Planning Proposal PP-2022-658

To rezone and increase height and FSR at 95-97 Stanhope Rd, Killara (Lourdes Retirement Village)

Ku-ring-gai Council Submission - October 2022

Figure 10: Depicting Fireline Intensity calculations (PHOENIX Rapidfire (no mitigation) scenario from RedEye, 2022 - showing the eastern and northeast sectors of the Subject Land having highest fire intensity impacts.

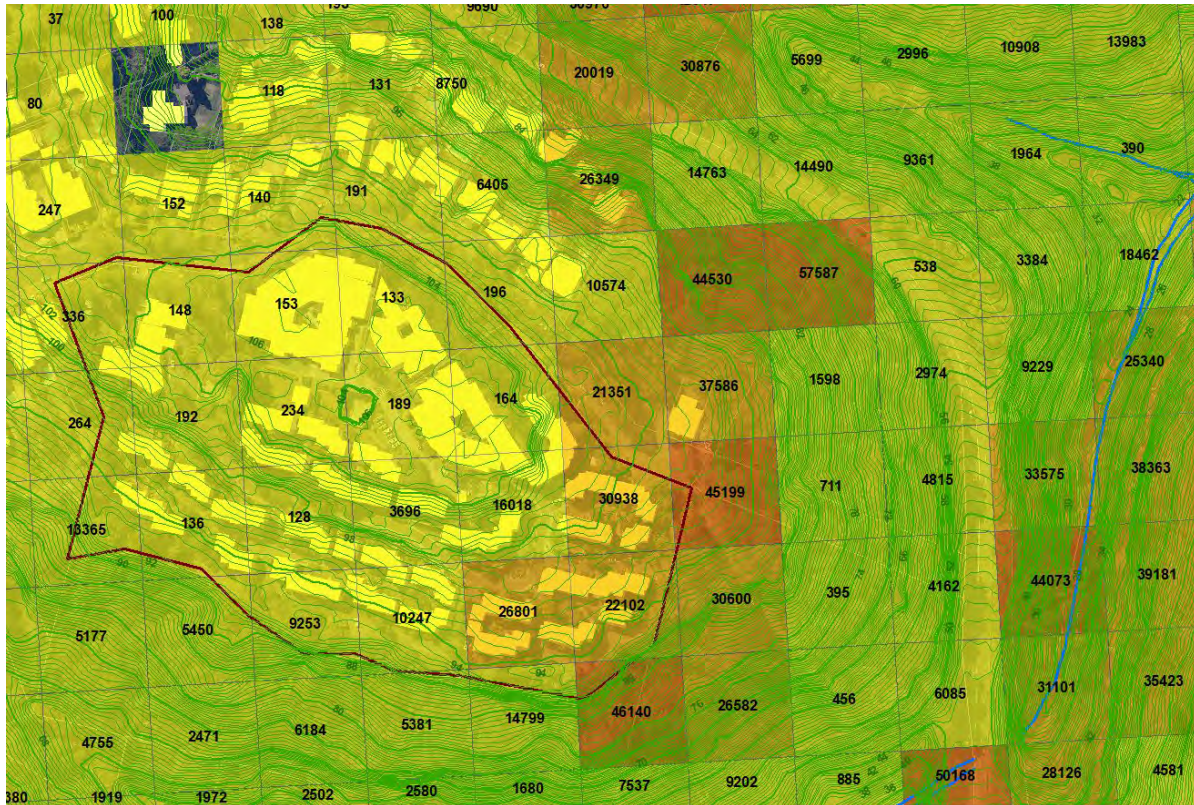
The eastern and south-eastern boundary area of the Subject Land is impacted most intensely by higher fireline intensities (see Figure 10) – due to the upslope runs and the significant continuity of bushland (hazard) to the north-east and east. The southern boundary is not indicated as having such a high fire activity – possibly due to the southerly (moister) aspect and moister vegetation types.

Figure 11: Relative 'ember density' map of the Subject land (RedEye PHOENIX analysis) – depicting highest ember density at the northeast sector and high ember attack in the eastern portion of the site.

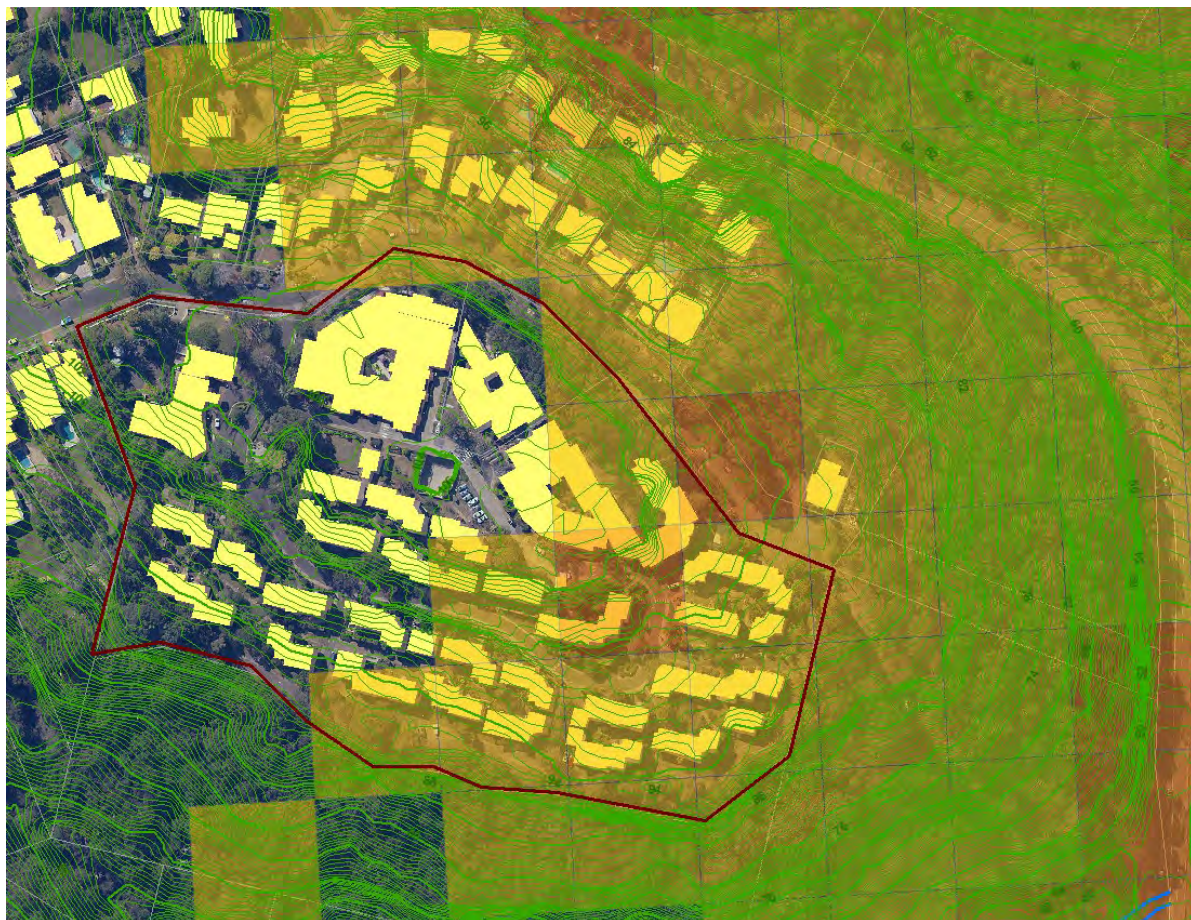
In addition, potential ember attack from bushfire activity has been modelled by RedEye in its PHOENIX simulations (see Figure 11), indicating highest ember densities in the eastern sector of the Subject land – particularly at the north-eastern interface area.

Figure 13: Existing and Proposed Road Network

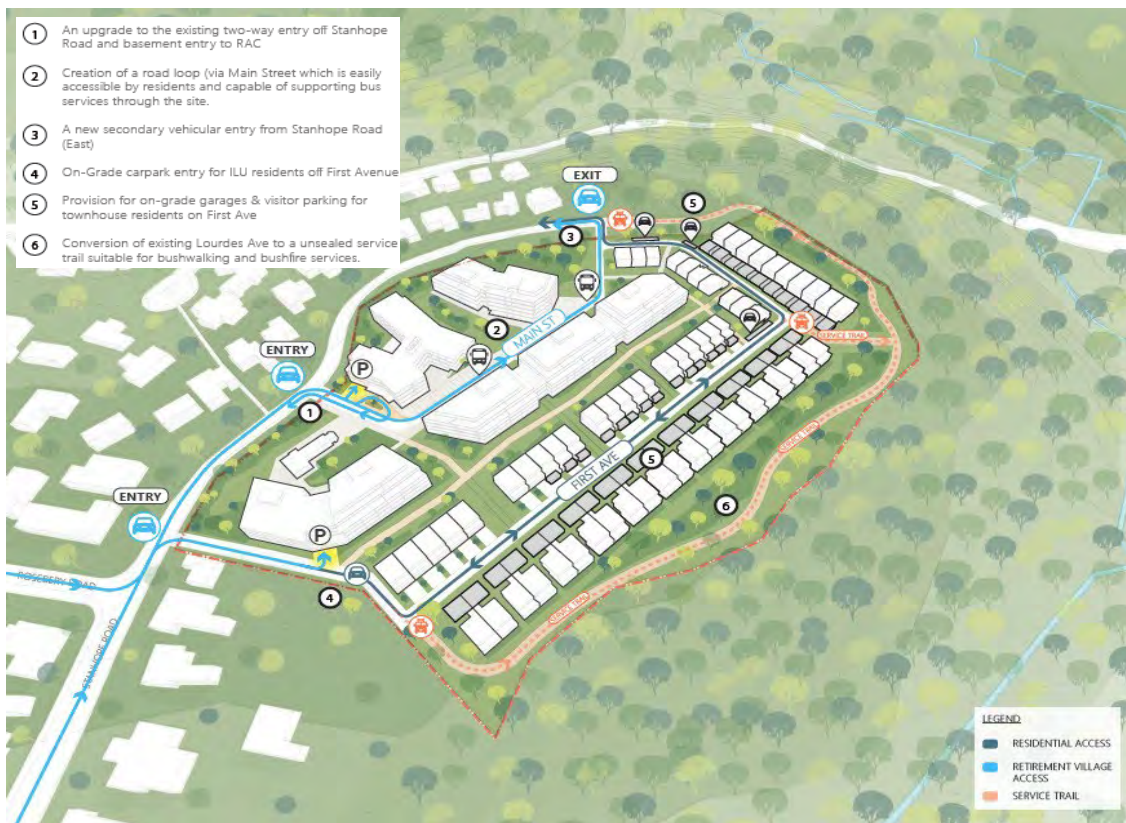
Access to and egress from the Subject Site, is limited and only via Stanhope Road which runs west into the suburb of Killara. There are a range of existing internal and proposed roads, which provide various connections to this main access and egress route (Figure 13 below).

Figure 9 - from North-West of the site with Main Street to the centre right showing ill-considered building height and separation ratios based on proposed master plan and heights

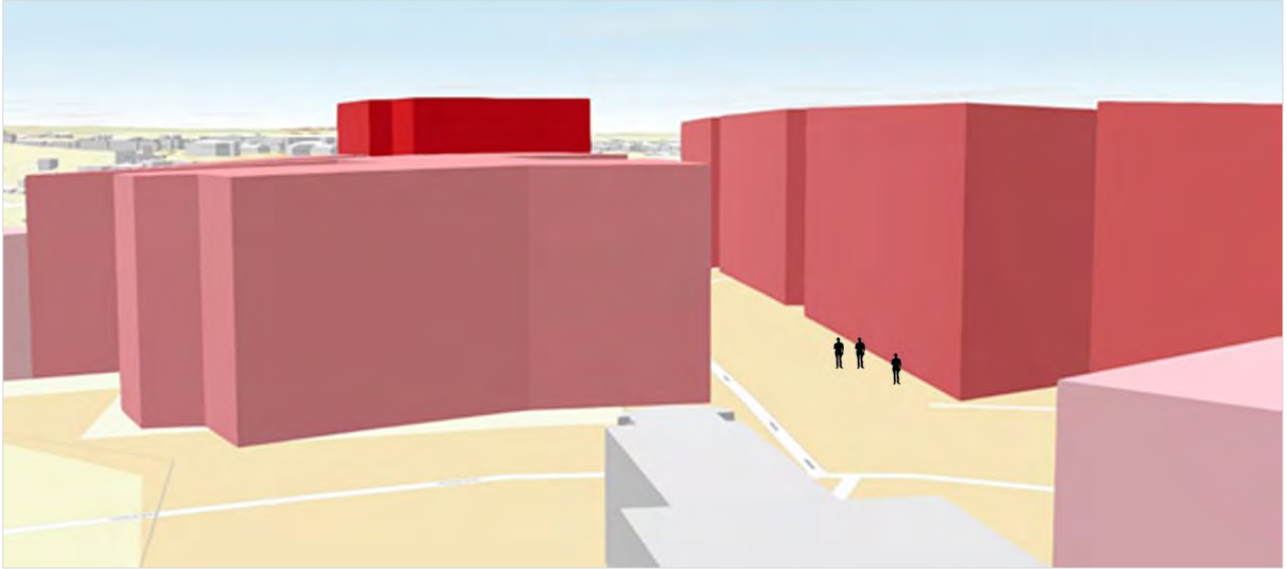
Figure 10 - from west of the site showing dense 'gun-barrel' built form outcomes, and poor ratios of landscape and built form, unlikely to achieve high levels of onsite amenity, privacy and retention of existing site values.

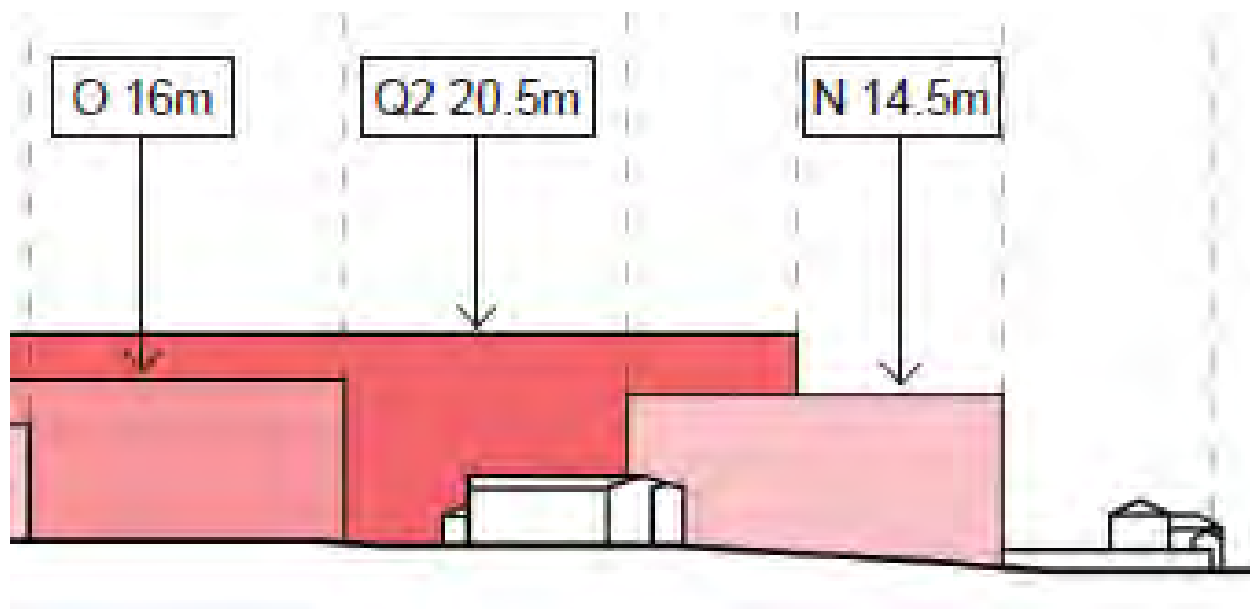
The submitted graphics of the proposed built form are inadequate to support the proponent's conclusions that the built form will have acceptable heritage impacts on the setting of heritage in the vicinity. The elevated views provided of the proposed built form disguise the bulk and height of

the development and is a view that will not be accessed or appreciated by anyone, except in flight. No photomontages or similar graphics are provided that show the visual relationship of the proposed six-storey and other proposed buildings to the two-storey Headfort House, or adjoining buildings of the conservation area, as it will be experienced by most people from ground level. No views to the proposed development from key surrounding vantage points, including the heritage items of parklands and the Stanhope Road streetscape, have been submitted to accurately represent its visual and heritage impact on the setting of historic buildings and parks in the vicinity.
